**Land On The North East of
J10 M42 Dordon/A5
PAP/2021/0663
LVIA Review**

Final report
Prepared by LUC
July 2022

**Land On The North East of J10 M42 Dordon/A5
PAP/2021/0663
LVIA Review**

Figure 3.1: Effects on the Strategic Gap, in relation to the Eastleigh Criteria

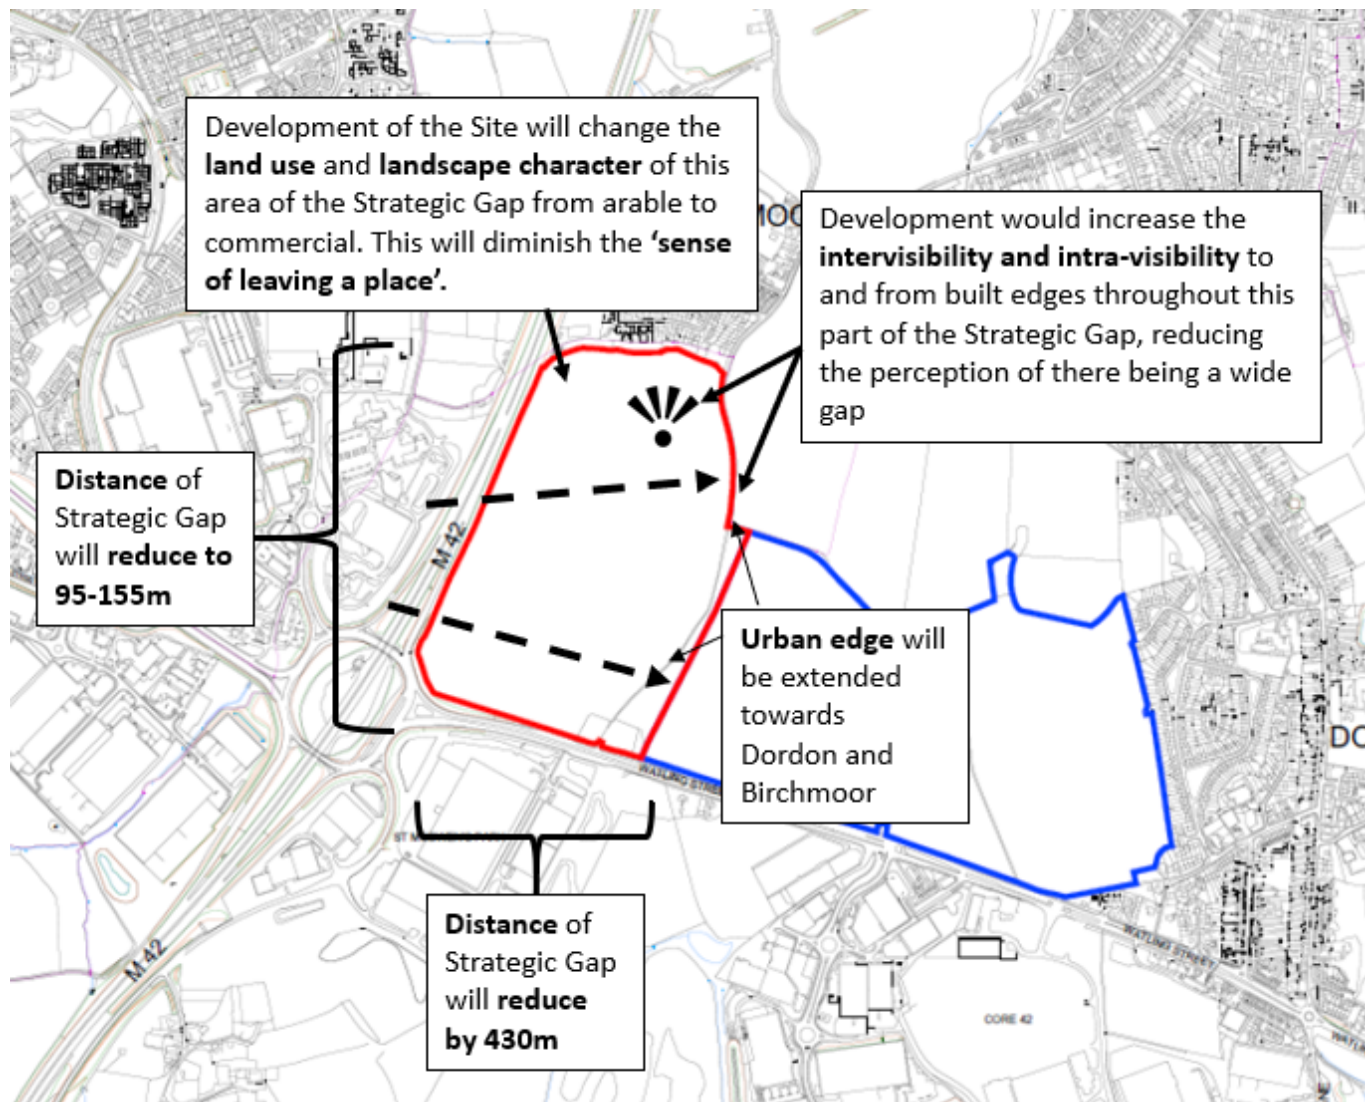
Eastleigh Criteria	LUC Comment
Distance	The Strategic Gap will be narrowed to 95-155m between Birchmoor and the commercial development to the south of the Site. The Strategic Gap between Tamworth and Dordon/ Polesworth will reduce by 430m, leaving a 777m gap.
Topography	The Site and the Strategic Gap in which it sits is quite flat and open, although rises slightly in the north. The flat and open nature of the Site emphasises the scale of the Strategic Gap. The Proposed Development of the Site, including creation of earth mounds for screening will alter the topography and openness of the Strategic Gap.
Landscape character/ type	The landscape character of the Site and Strategic Gap is mainly arable in nature with occasional tree belts and hedgerows. The Proposed Development would introduce buildings of a large scale which would fundamentally change the character of the Strategic Gap and reduce the openness which is characteristic of the area.

Vegetation	There is limited vegetation on the Site and in this part of the Strategic Gap. Hedgerows are found around the boundary of the Site, and in adjoining areas of the Strategic Gap, but there is no strong vegetated boundary to extend to or which might provide a sense of separation. Planting of native woodland within the Site, and off-site, could provide greater sense of physical and perceptual separation. New planting would take a long period to mature and to become effective.
Existing uses and density of buildings	The existing use of the Site is arable land. There are no existing buildings on the Site. The Proposed Development would introduce buildings of a large scale which would take up a large proportion of the Site and would introduce woodland belts (for screening purposes) which are not characteristic of the current vegetation found on Site.

Eastleigh Criteria	LUC Comment
Nature of urban edges	Built development is found in all directions around the Strategic Gap. Built development, in the form of main roads and settlements are immediately adjacent to the Site to the north, south and west. However, boundary vegetation largely screens visibility of this built development and softens the boundaries of the Strategic Gap. The Proposed Development would incorporate mitigation planting. However, given its scale, there is no obvious boundary where the Proposed Development could extend up to which might soften a new urban edge to the Strategic Gap.
Inter-visibility (the ability to see one edge from another)	The open and flat nature of the Site and Strategic Gap enables intervisibility from one edge to the other. The Proposed Development will reduce this intervisibility by screening views across the Strategic Gap. Intervisibility from new edges would increase given the narrowing of the gap between the edges.

Intra-visibility (the ability to see both edges from a single point)	The open and flat nature of the Site and Strategic Gap enables intra-visibility from across the Site. The Proposed Development will reduce this intra-visibility by screening views across the Strategic Gap. It will also increase intra-visibility to the new edge, given the narrowing of the gap between the edges.
The sense of leaving a place	Currently, there is a distinct sense of leaving the surrounding areas (Tamworth, Birchmoor, Dordon and the commercial area to the south of the Site) when entering the Strategic Gap area. The Strategic Gap contrasts strongly with the surrounding built development due to its open, agricultural landscape. The Proposed Development would diminish the sense of leaving a place by changing the land use and character of the Strategic Gap. This would be achieved due to extending built development across the Strategic Gap between Birchmoor and the commercial development to the south, and Tamworth and Polesworth.
